Product hierarchy no. *			Part no.	SBU	Type / Description	Customer part no.
SBU	PG	PUG	Type			
02	005	116	0000001135	See list below	Power entry module	GSF1

Product Change Notification						GSF1 Power entry module	
owner	creation date	release date	released by	change order no	rev	page	D10-032-995
sariogar	10.01.2019	25.03.2019	blumhe	2016834	A	1 of 3

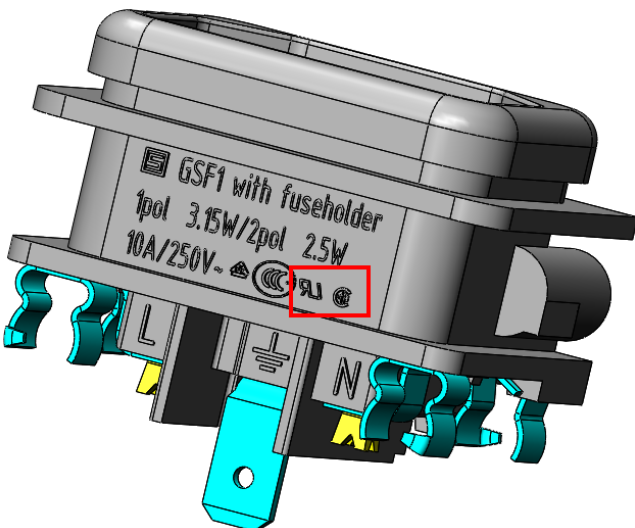
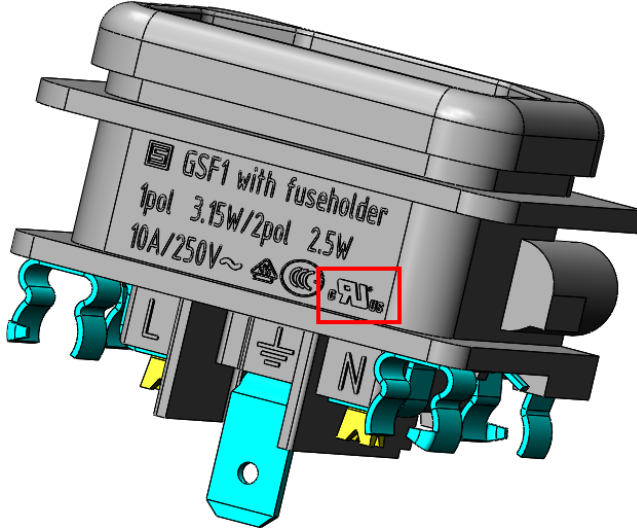
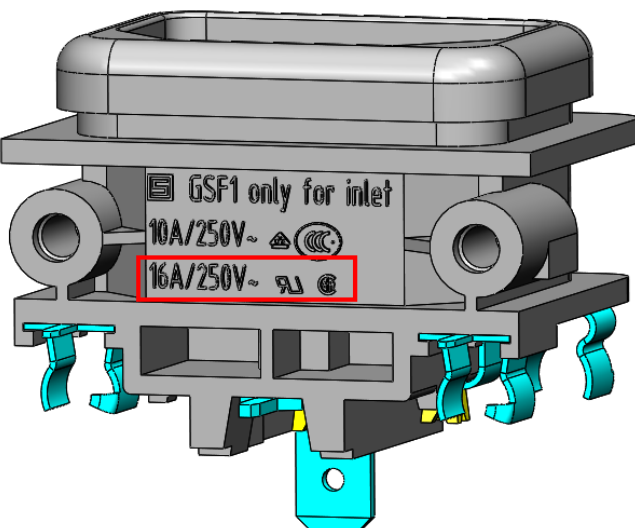
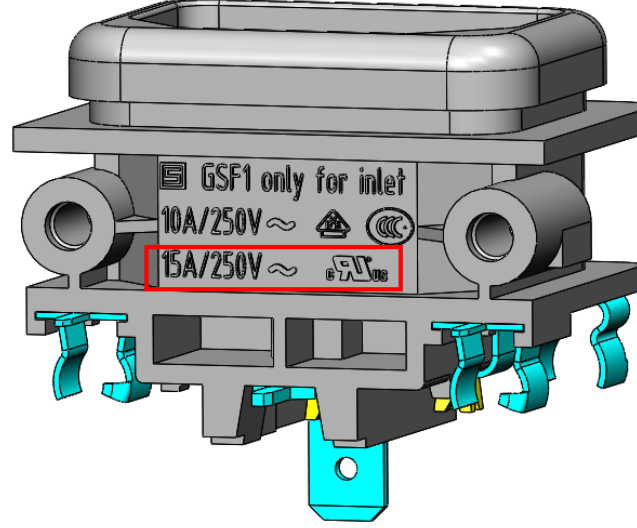
- Change of rating and approval markings on the product
- Modified packaging label

Old product appearance	New product appearance
<p>Old approval UR, CSA</p> 	<p>New approval cURus</p> 
<p>Old rating and approval 16A/250V~, UR,CSA</p> 	<p>New rating and approval 15A/250V~, cURus</p>

Standards update according to the new UL/CSA 60320-1
